**ADDENDUM
NO. 2**

**Three Rivers Community Schools High School Music Suite
700 Sixth Avenue
Three Rivers, MI 49093**

A/E Project 5-5834

ADDENDUM 002

High School Music Suite Remodel
Site Logistics Plan
Revised: 04/23/2024

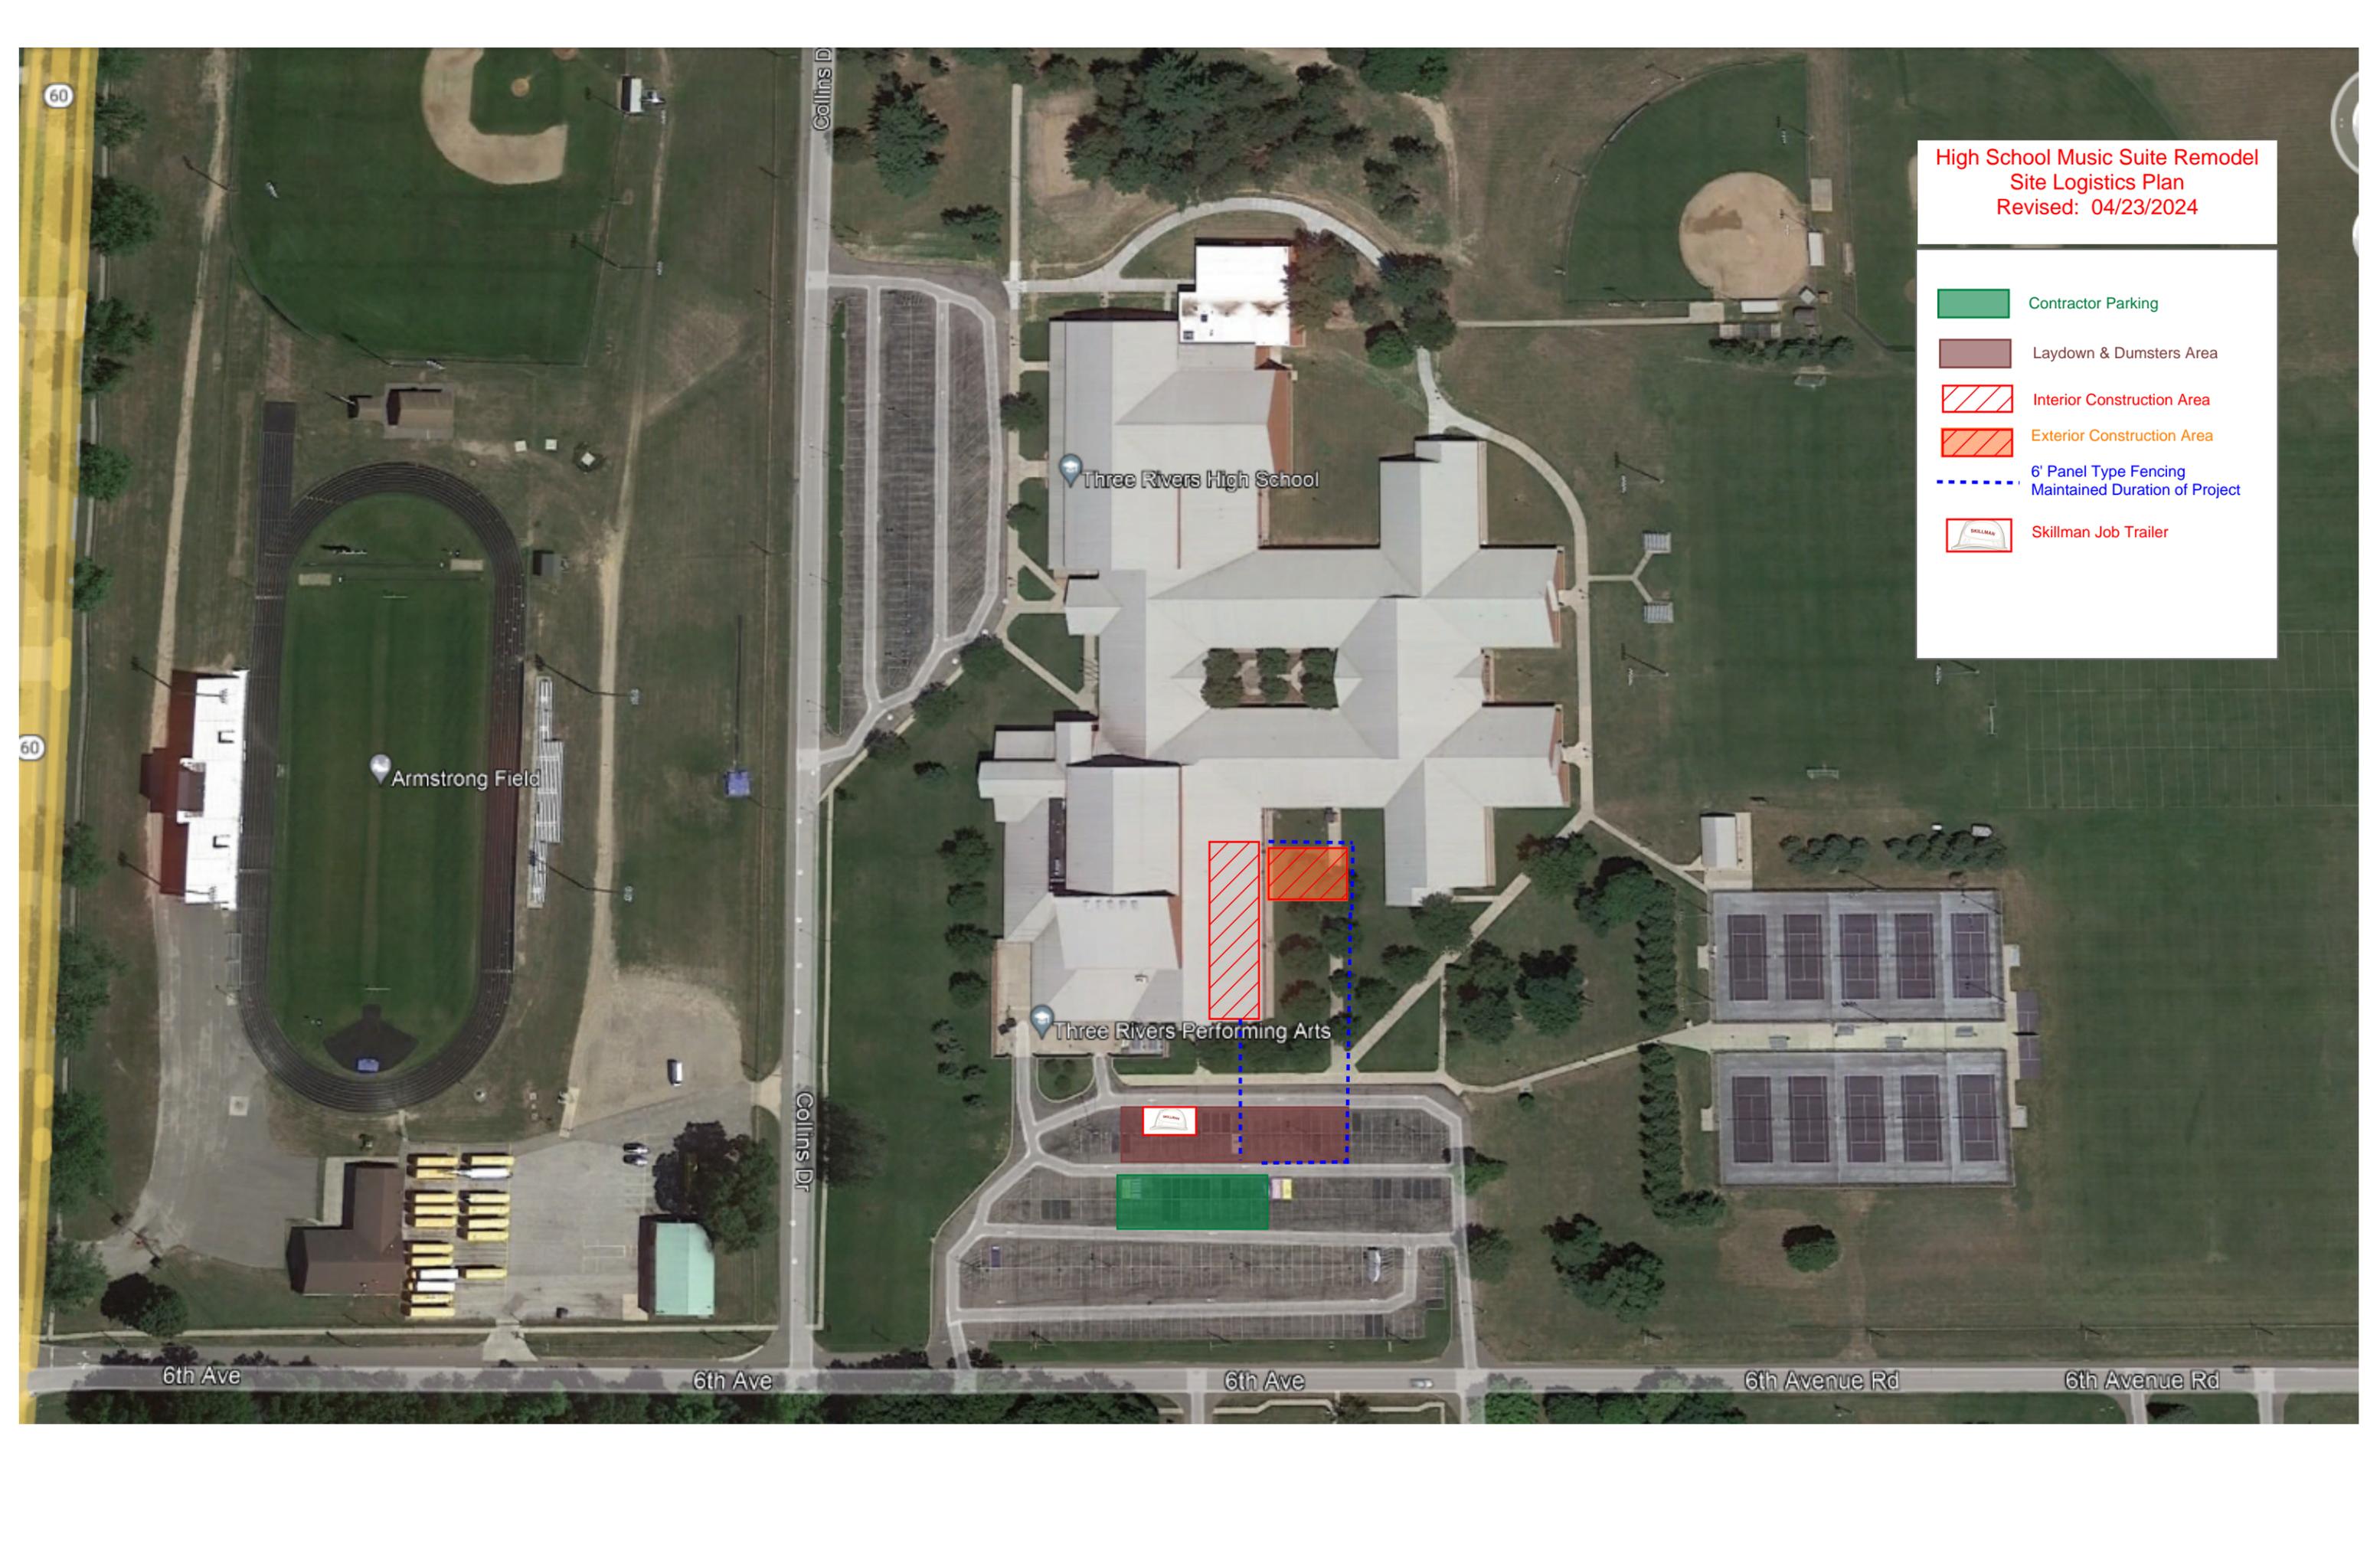
1. General Trades contractor to provide and maintain Ram Board to protect existing floor finishes in Terrazzo corridor and any other areas where construction traffic will occur.
2. Section 01 53 10 – Fences/ Part 2 – Products / 2.01 Materials: Letter A, change to Allow for 600 Lineal Feet of 6' high chain link fencing with gates. Refer to Site Logistics plan for layout. Letter B, change to Allow 0 Lineal Feet of plastic construction fencing.

1. See Guideline Schedule attached.
2. See Site Logistics Plan attached.

DOOR TYPE LEGEND
1/4" = 1'-0"

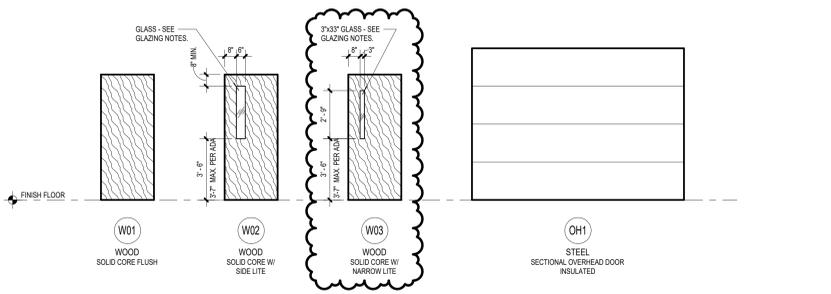
ITEM NO. 1 SHEET A5.01 – DOOR & FRAME SCHEDULE (REISSUED)

- A. Revised door type at door H117A to now be W03 in lieu of A01.
- B. Added door type W03 to the Door Type Legend.

UNIT 'H' FIRST FLOOR ELECTRICAL DEMOLITION PLAN
1/8" = 1'-0"

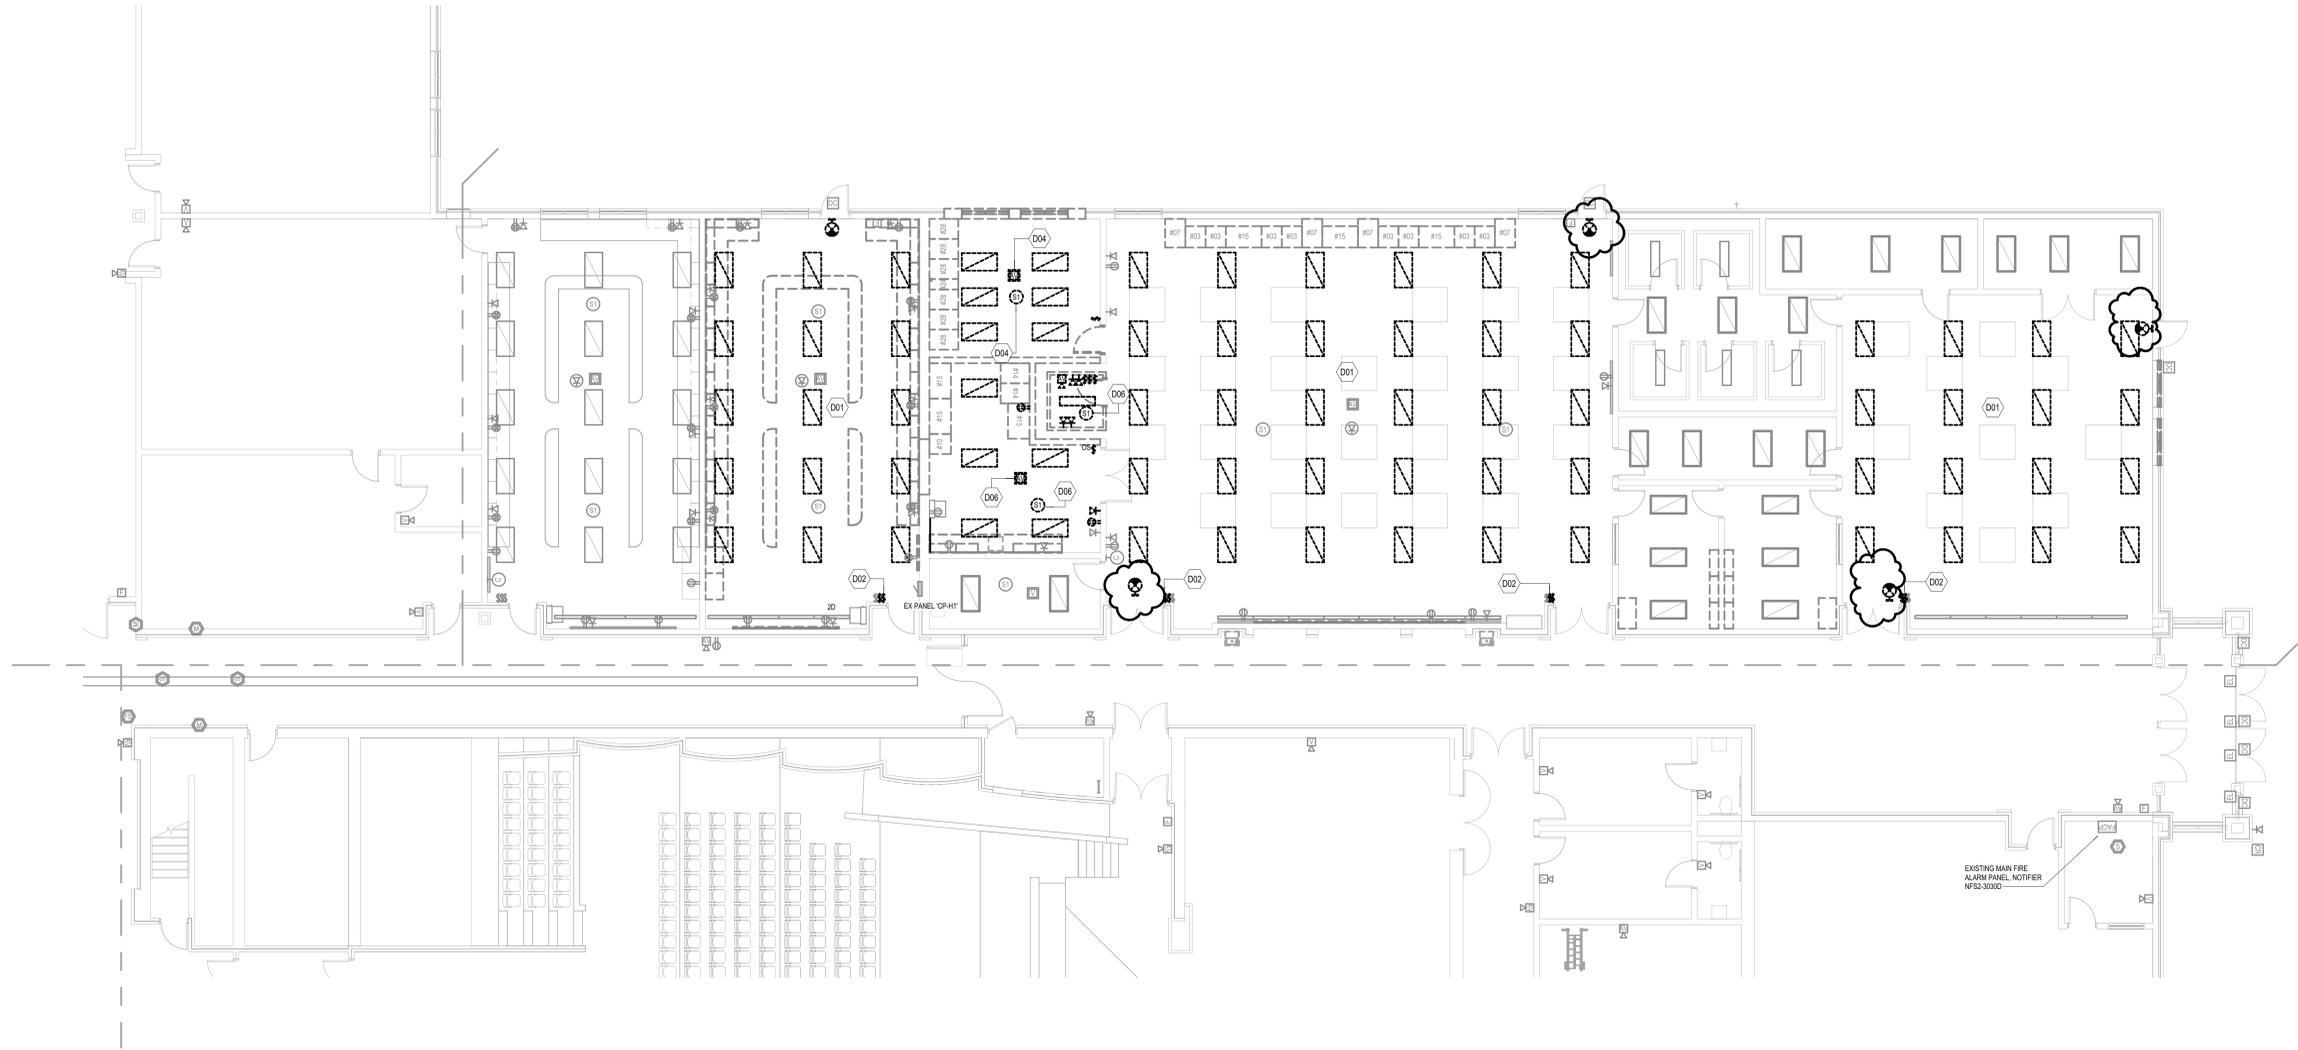
ITEM NO. 2 SHEET E1.1H UNIT 'H' FIRST FLOOR ELECTRICAL DEMOLITION PLAN (REISSUED)

Refer to the plan for the added exit signs to be demolished.

NORTH
UNIT 'H' FIRST FLOOR LIGHTING PLAN
1/8" = 1'-0"

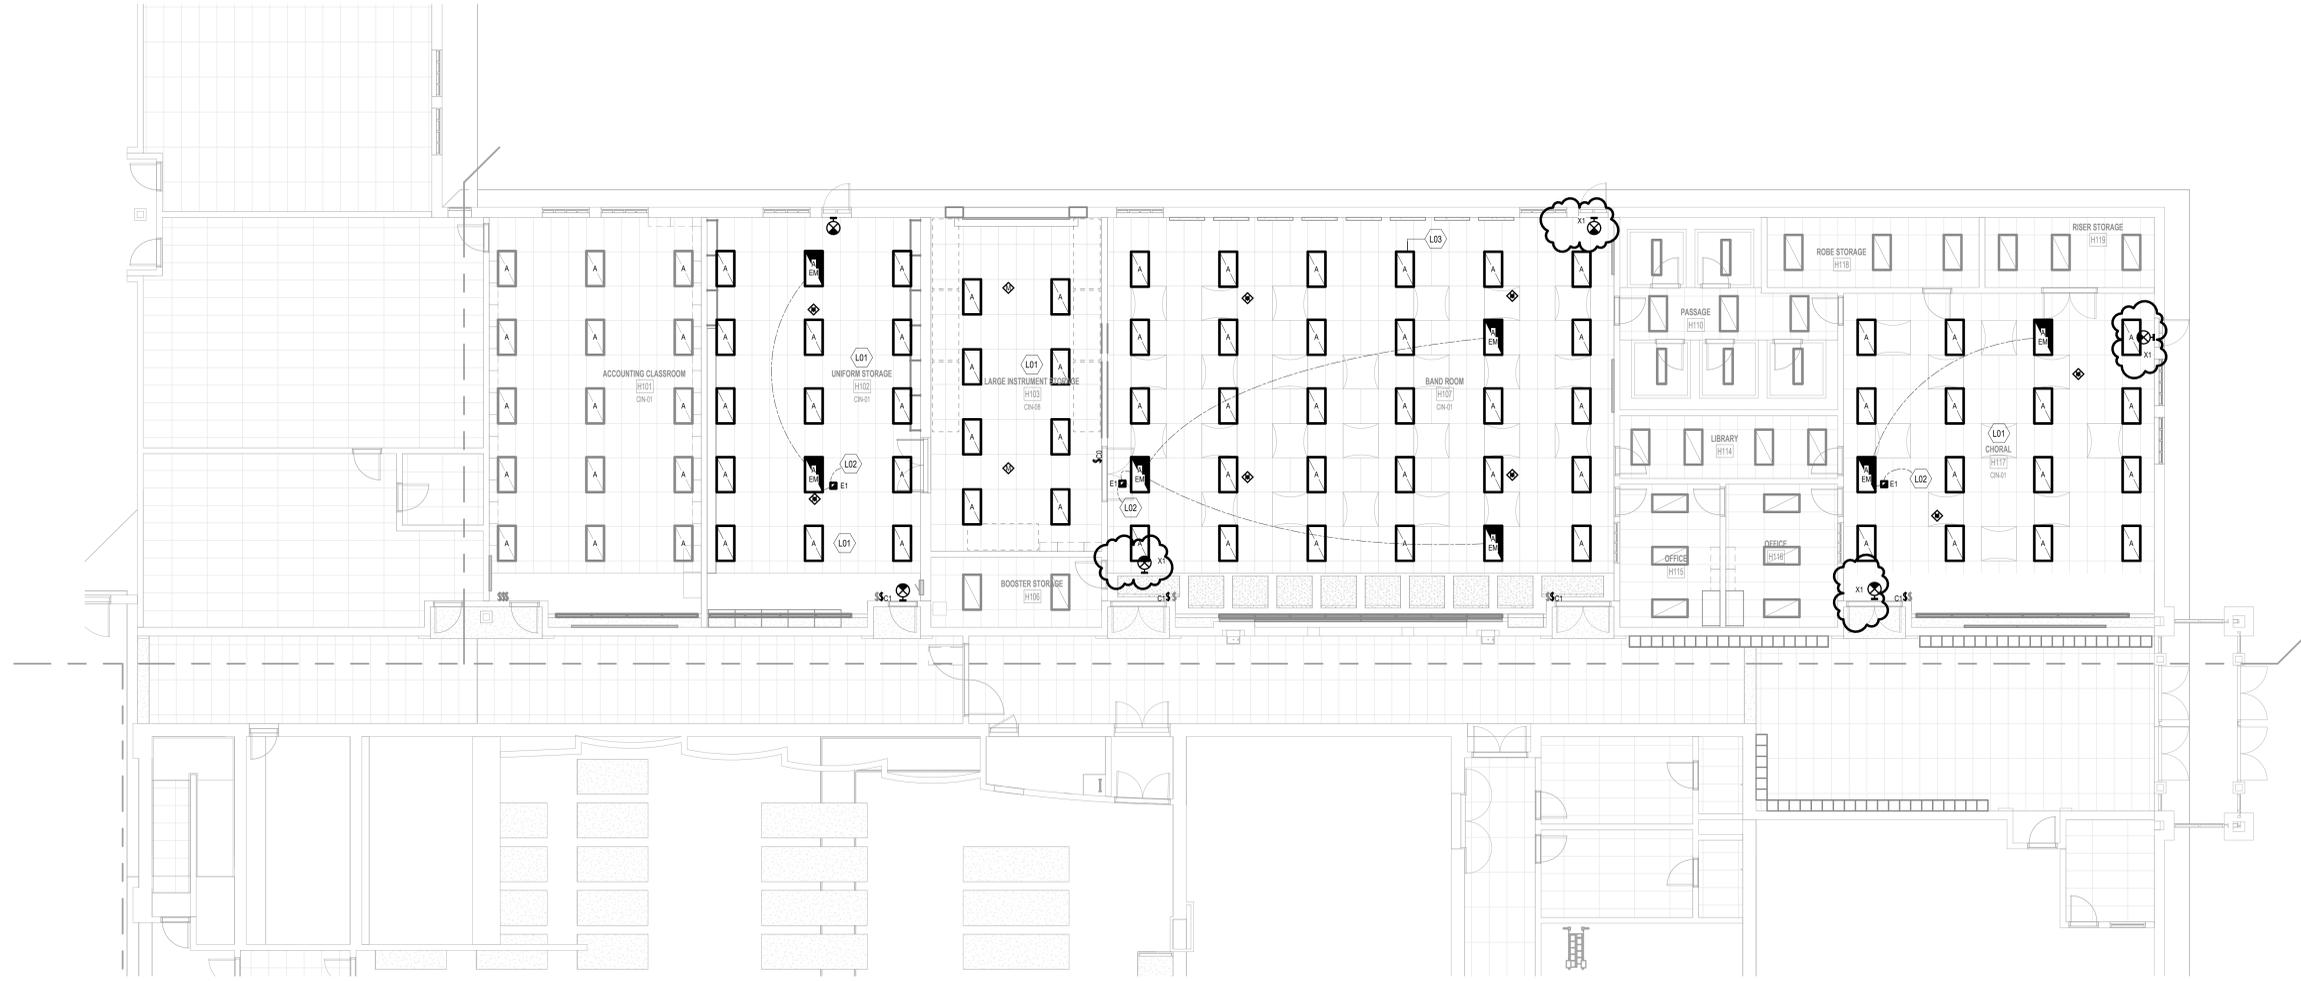
ITEM NO. 3 SHEET E3.1H UNIT 'H' FIRST FLOOR LIGHTING PLAN (REISSUED)

Refer to the plan for the new exit signs. These exit signs are to be tied to the existing emergency circuit.
